Title: **STAGE 1 ROAD SAFETY AUDIT**

Holybanks Swords

Client: **Cairn Homes/Waterman Moylan**

Report reference: **0934R01**

Drawing 17-088 P002 Rev -, Jugback Terrace vehicular access.

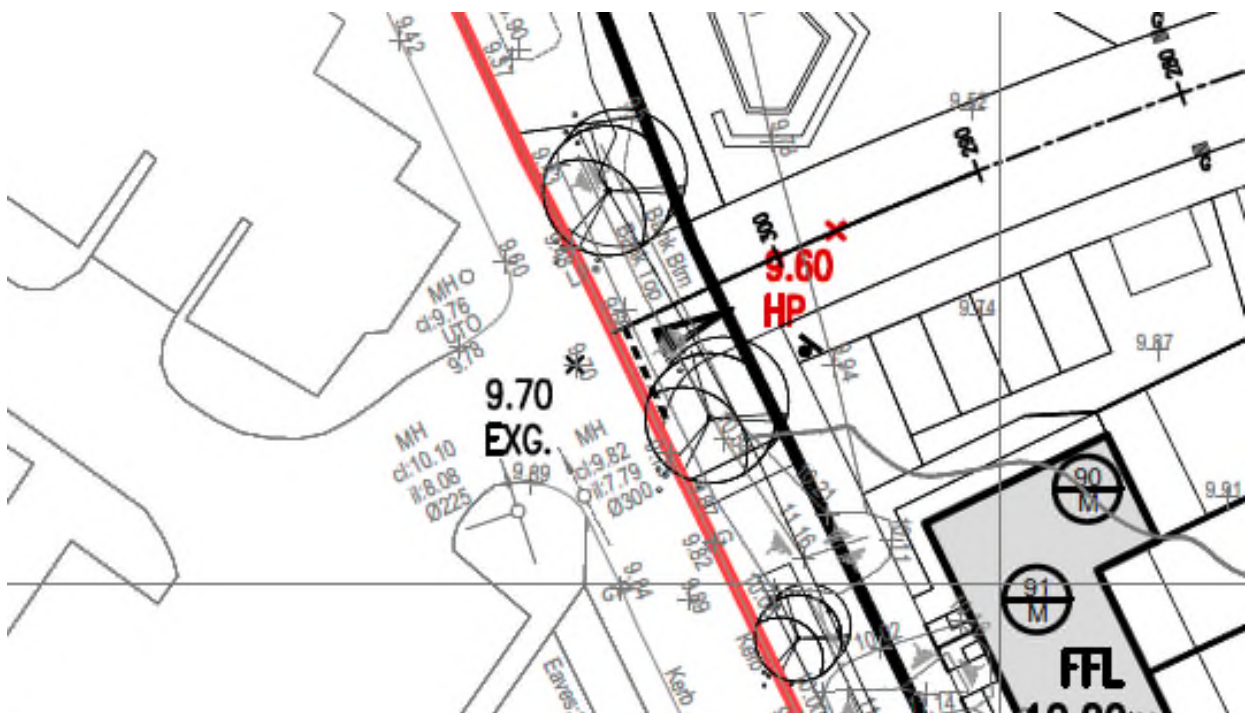
It is proposed to provide a crossroads on Jugback Terrace with a yield control for vehicles exiting the proposed development. There is a risk that given the relatively low number of vehicles that will be travelling from the single dwelling at the end of Jugback Terrace that drivers exiting the proposed development may not expect conflicting traffic and may travel across Jugback terrace without yielding or stopping resulting in side-impact collisions.

It is recommended that the development access be staggered from the access to Applewood Lane.

3.1	Yes	No	Due to the very low traffic likely to be on Jugback Terrace it is proposed to change the priority. A stop line will be installed on both sides of Jugback Terrace. See attached amended drawing no. 17-088/ P002 Rev A	Yes

Drawing 17-088 P011 Rev -, Glen Ellan Road, Cycle Track.

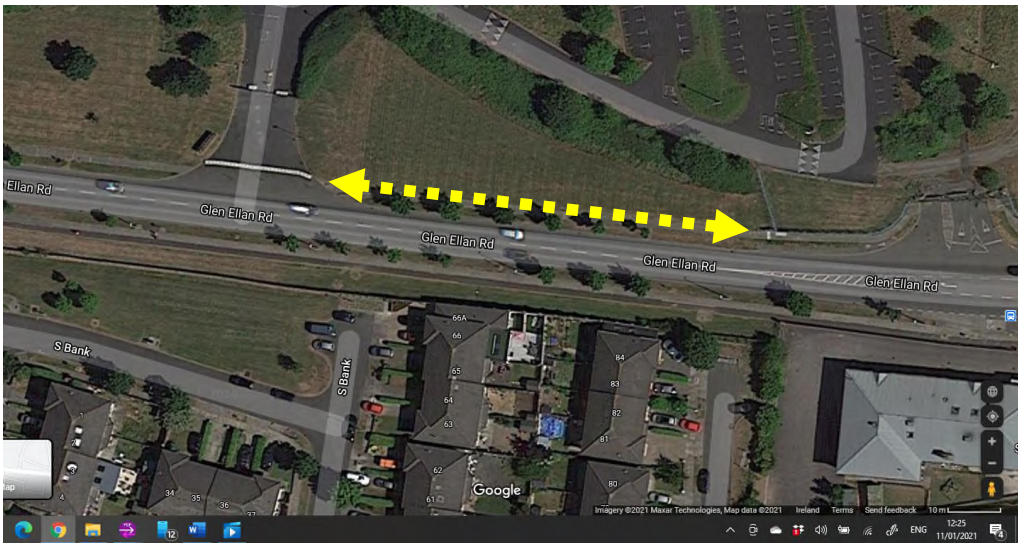
It is proposed to terminate the cycle track at the access to private lands at the eastern boundary of the development. This will lead to a short discontinuity in cycle facilities between this point and the approach to the Balheary Road Junction where the cycle track recommences. The merging of cyclists with general traffic will lead to an increased likelihood of a collision.

It is recommended the cycle track be made continuous along the verge of Glen Ellan Road.

3.3	No	No	Junction priority is proposed to be changed as per response to Problem 3.1 above.	Yes
3.4	Yes	Yes	Continuity of cycle track along Glen Ellen Road is outside the applicants control. The matter will be referred to Fingal County Council. We would note that the lands fronting this section of Glen Ellen Road are zoned for development and consequently are likely to be developed in the future. Continuity of the cycle lane can be provided at this time.	Yes

Drawing 17-088 S105 Rev -, Balheary Road Junction.

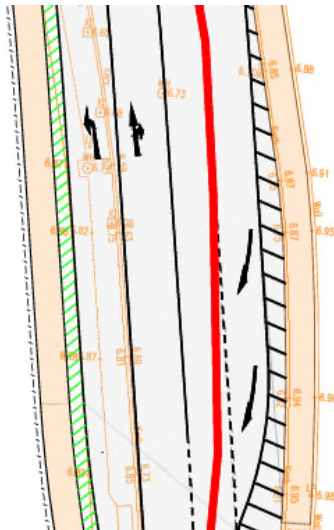
It is proposed to provide two right turning lanes from Glen Ellan Road to Balheary Road however the second lane terminates on approach to the access to the Swords Business Campus. There is a risk of side-swipe collisions as drivers merge at this point. The addition of extra capacity at the junction would result in a reduction in safety.

3.6	Yes	No	Traffic modelling of the junction has optimized the traffic signals, however this still requires 2 no. right turning lanes. Additional signage will be provided to warn motorists regarding merging traffic. The junction upgrade is proposed as a temporary measure and will be subject to a future upgrade by Fingal County Council	Yes

Drawing 17-088 S105 Rev -, Balheary Road Junction.

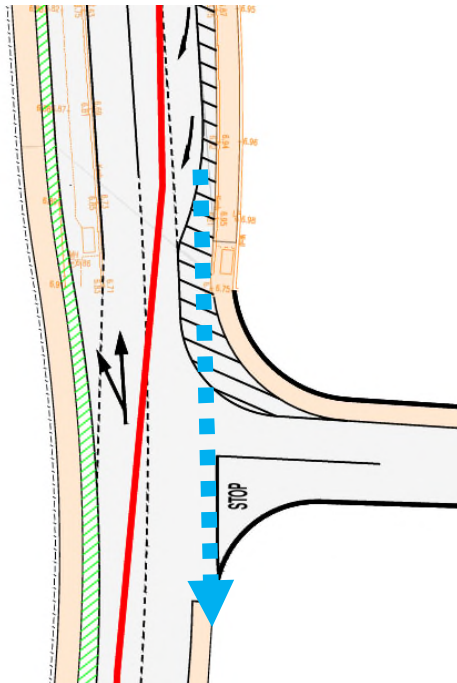
It is proposed to merge vehicles from two lanes to one at the approach to the Swords Business Park access. There is a risk that the road markings may become faded over time or not be clearly distinguishable during adverse weather. As a result, drivers in the nearside lane may not realise that the lane ends and may travel across the junction mouth either colliding with exiting vehicles or colliding with the footpath/verge on the opposite side of the access due to misaligned carriageway edges on both sides of the access.

It is recommended that the hatched termination of the lane is replaced with a solid buildout.

3.7	Yes	Yes	Solid buildout will be provided.	
3.8	Yes	Yes	Cycle lane will be provided	
3.9	Yes	Yes	The proposals currently shown are temporary pending the upgrade of the junction to a fully signalized junction by Fingal County Council as per current public display. It is expected that the proposals shown will not need to be constructed, however in the event that they are needed this arrangement will only be for a short period of time.

Drawing 17-088 S135 Rev -, Estuary Road Roundabout.

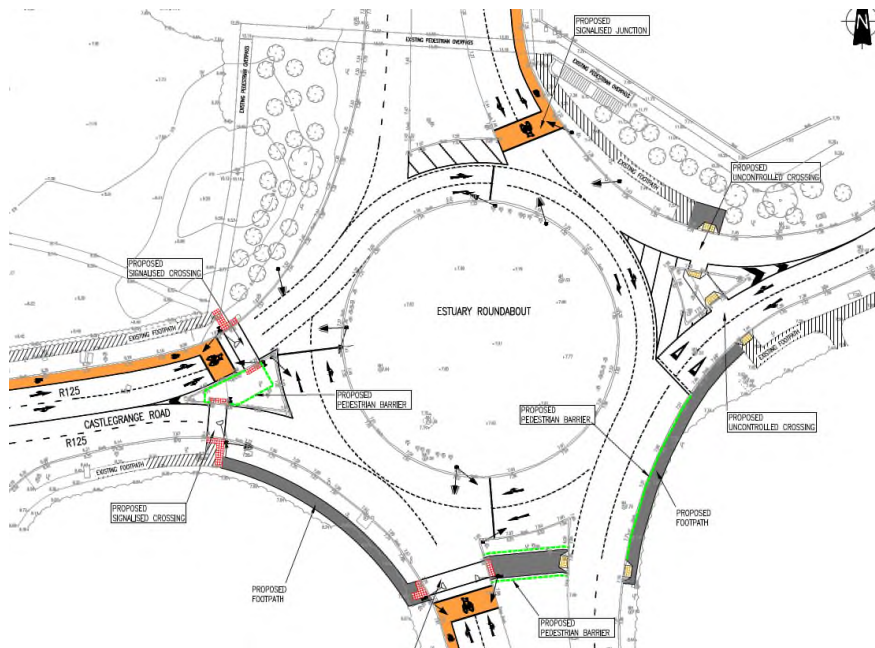
It is proposed to partially signalise Estuary Road Roundabout. It is also proposed that cyclists will use the circulating carriageway and enter the spiral type lane system with other traffic and move into the outer lane at the signals via an advance stop line. There is a risk that cyclists will be struck by weaving traffic on the circulating carriageway.

It is recommended that the roundabout be converted to a signalised junction similar to the layout currently being displayed to the public on the Fingal Co. Co. website for the Swords Connectivity Project.

Drawing 17-088 P002 Rev -. General Internal Roads.

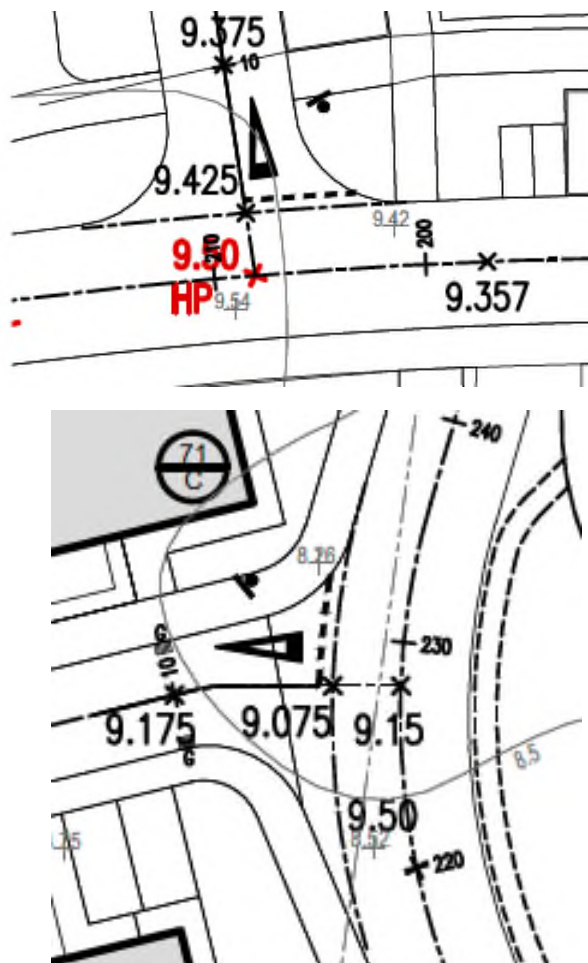
The corner radii at the internal junctions appear to be large which leads to higher turning speeds, longer crossings and higher severity injuries if vulnerable road users are struck.

It is recommended that corner radii are provided in accordance with the guidance provided in DMURS.

3.11	No	No	Corner Radii are generally 4.5m to accommodate occasional large vehicles (refuse trucks). See drawing 17-088/P004 and P005 which complies with DMURS for occasional larger vehicles as per Figure 4.43 in DMURS	Yes

Drawing 17-088 P002 Rev -. General Internal Footpaths.

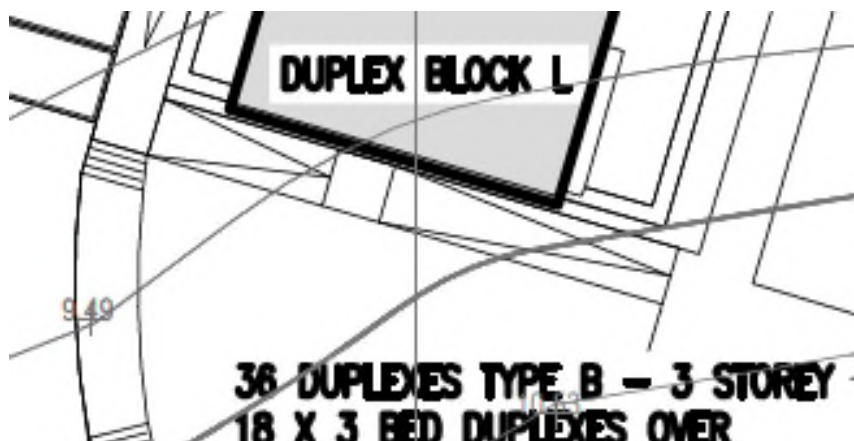
The internal footpaths within the development have ramp type markings and transverse markings. It is unclear what the transverse markings represent. There is a risk that if the gradients are excessive on the footpaths that certain areas will not be accessible to the mobility impaired.

It is recommended that footpath gradients within the development comply with the limits set out in Part M of the Building Regulations.

3.13	Yes	Yes	Footpath gradients will be reviewed at detailed design stage in order to comply with Building Regulation guidelines for mobility access. The traverse lines are a landscape architect paving feature which have been removed from our engineering drawings.	
3.14	Yes	Yes	Uncontrolled pedestrians' crossings have been amended to ensure perpendicular crossings.	
3.15	Yes	Yes	Gullies have been relocated immediately upstream of all uncontrolled pedestrian crossing points and road levels adjusted to have the low at the new gully locations.	
3.16	Yes	Yes	Disabled space has been relocated	
3.17	Yes	Yes	Additional traffic calming measures will be provided at detailed design stage, which may include build outs along the open space to reduce traffic speeds and or raised tables.	
3.18	Yes	Yes	Road has been extended to provide safe access to on-curtilage parking at unit 94.

Drawing 17-088 P002 Rev -. General Internal Footpaths.

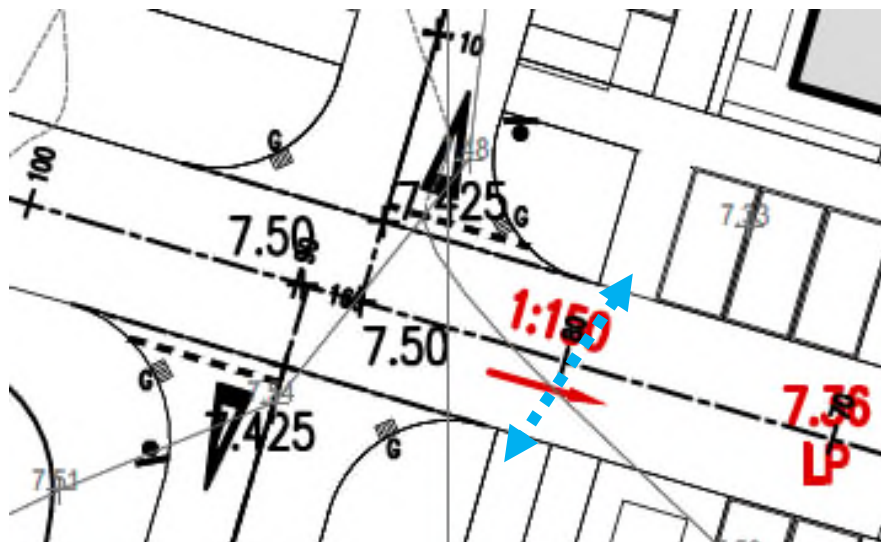
Some internal footpaths do not align at uncontrolled crossing points of the road network. This could lead to difficulties for crossing of the carriageway for blind or partially sighted pedestrians.

It is recommended that footpaths at the opposite side of uncontrolled crossings align perpendicular to the direction of vehicular traffic travel.

Drawing 17-088 P002 Rev -.

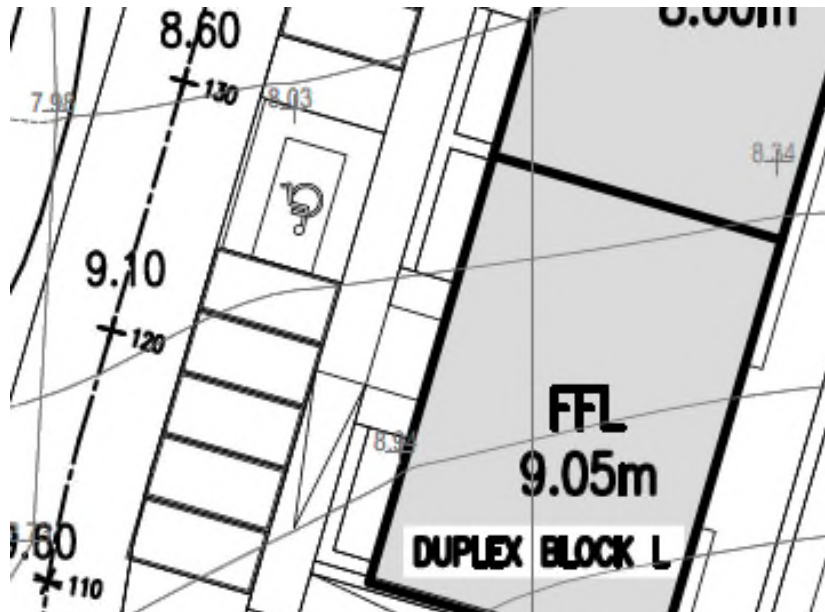
The proposed disabled parking space outside Block L is orientated at 90 degrees to the adjacent parking spaces. It is unclear how a driver could enter/exit this space if the adjacent spaces are occupied. This could result in a lack of facilities for disabled drivers, resulting in parking in areas that may be hazardous for other road users such as footpaths.

It is recommended that the parking layout be revised.

Drawing 17-088 P002 Rev -. Access Road from Jugback Terrace.

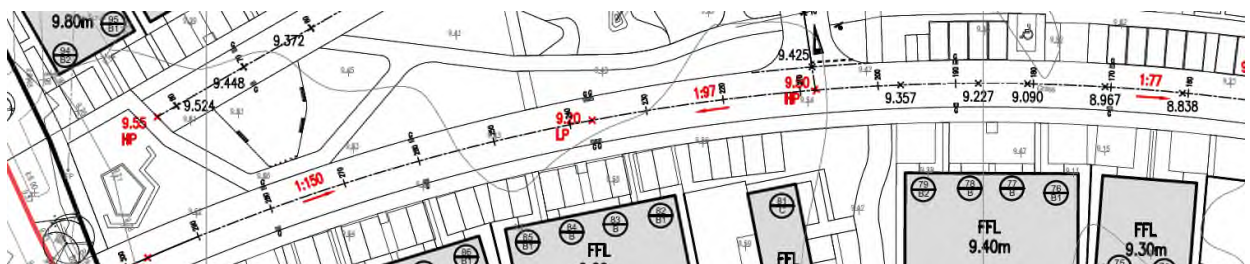
The proposed access road from Jugback Terrace has a constant large horizontal radius, is 300m long and is the priority route along its length. This may lead to high speeds and result in high severity collisions if vulnerable road users are struck.

It is recommended that a more sinusoidal alignment is provided or that alternative traffic calming measures be provided.

Drawing 17-088 P003 Rev -. Parking spaces at unit 94.

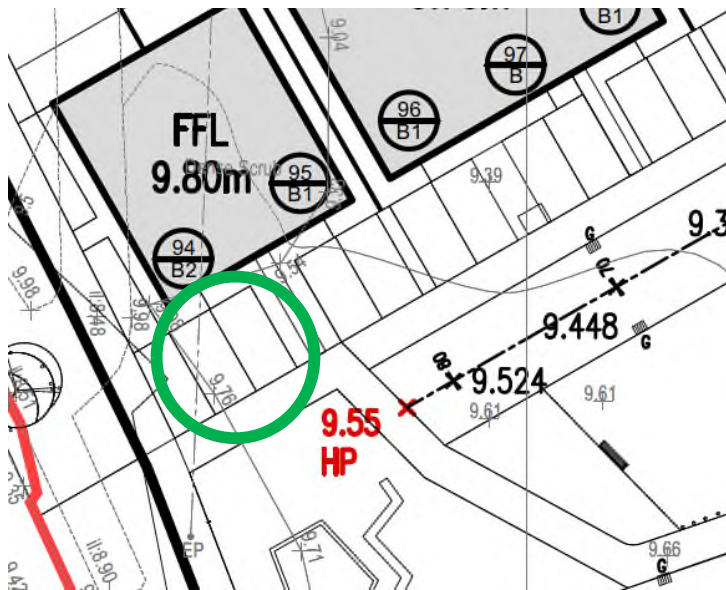
There is no access for the on-curtilage car parking spaces for unit 94. This could lead to drivers travelling/reversing on the footpath or green areas where they could collide with children

It is recommended that road access be provided to unit 94.
